ADDENDUM #2

MAINE DEPARTMENT OF CORRECTIONS

PAVING PROJECT

(BGS 3631)

SHEET 3 OF 8

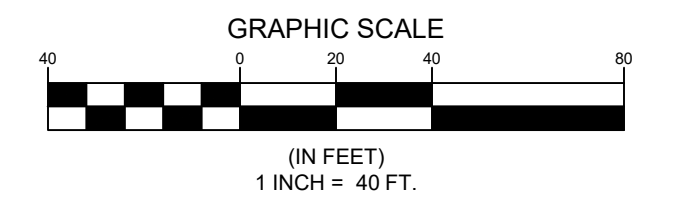
1. Revise the description of work adjacent to the sliding security gate from “shim and overlay pavement as required to eliminate speed bump under sliding gate. Raise grade as required to maintain a 4" space between bottom of gate and pavement.” to “Remove pavement and shim gravel as required to eliminate speed bump under sliding gate. Raise grade as required to maintain a 4" space between bottom of gate and pavement”.

2. Revise the description of work for the existing gravel parking lot adjacent to the maintenance building from “Pave existing gravel parking area. See grading plan” to “Excavate existing gravel as required to install gravel and pavement to match full depth pavement section. Grade and compact to provide drainage prior to paving. See grading plan”.

3. A note was added for work associated with the existing gravel parking lot stating “Contractor to provide loam and seed at transition from paved areas to non-paved areas, typ”.

4. Revise the description of work for the existing gravel driveway adjacent to the maintenance building from “Pave existing gravel parking area. See grading plan” to “Excavate existing gravel as required to install gravel and pavement to match full depth pavement section. Grade and compact to provide drainage prior to paving. See grading plan”.

5. A note was added for work associated with the existing gravel driveway adjacent to the maintenance building stating “Contractor to provide loam and seed at transition from paved areas to non-paved areas, typ”.
